# Access Compliance Report

### (Curb Ramps)

Intersection ID: 20439	Main Street: FAIRVIEW_RD	Cross Street: SHARON_RD	Location: SE
ADA ID: B47F8CF6121D	Ramp Type: BlendTrans2	Initial Pass/Fail: Fail	Overall Compliance: No
Codes/Mitigation Info/Possible Solution			Severity Score: 10
			Field Measurements/Component Compliance

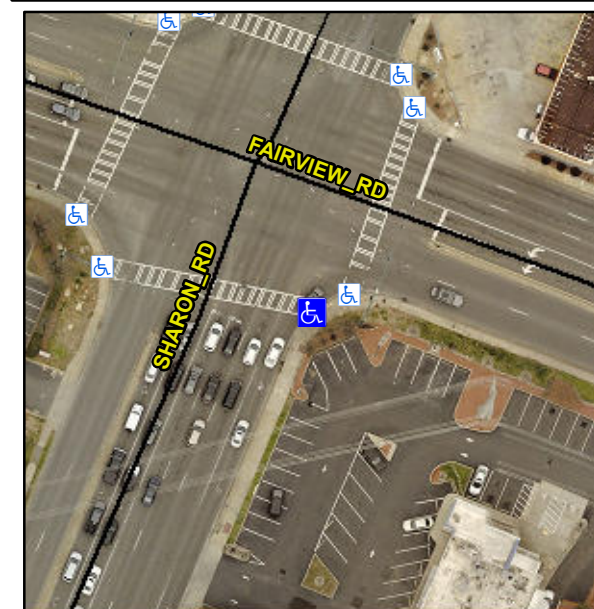
**R304.5.1, R304.5.3**

Compliance	Description	Data	Compliance	Description	Data
N/A	Ramp Length (in)	94.0	Yes	BlendTrans Slope (%)	4.1
No	Ramp Width (in)	37.0	No	BlendTrans XSlope (%)	4.3
N/A	Flare Type LT	N/A	N/A	Flare Type RT	N/A
N/A	Flare Slope LT (%)	N/A	N/A	Flare Slope RT (%)	N/A
N/A	Flare Traversable LT?	N/A	N/A	Flare Traversable RT?	N/A
N/A	Landing Length (in)	N/A	N/A	DWS Provided?	N/A
N/A	Landing Width (in)	N/A	N/A	DWS Contrast?	N/A
N/A	Landing Slope (%)	N/A	N/A	DWS Length (in)	N/A
N/A	Landing X Slope (%)	N/A	N/A	DWS Full Width?	N/A
N/A	Landing Curb? (Y/N)	N/A	N/A	DWS Offset (in)	N/A
N/A	Shared Landing?	N/A			
N/A	Gutter Ponding?	N/A	N/A	Gutter Slope (%)	N/A
N/A	Gutter Lip Ht (in)	1.0	N/A	Gutter X Slope (%)	N/A
N/A	Painted X Walk1?	Yes	N/A	Painted X Walk2?	N/A
	X Walk 1 Direction	To NW		X Walk 2 Direction	N/A
	X Walk 1 Width (in)	100.0		X Walk 2 Width (in)	N/A
	X Walk 1 Slope (%)	2.7		X Walk 2 Slope (%)	N/A
	X Walk 1 X Slope (%)	1.8		X Walk 2 X Slope (%)	N/A

**Remove & Replace Curb Ramp With Two New Directional Ramps or Equivalent.**
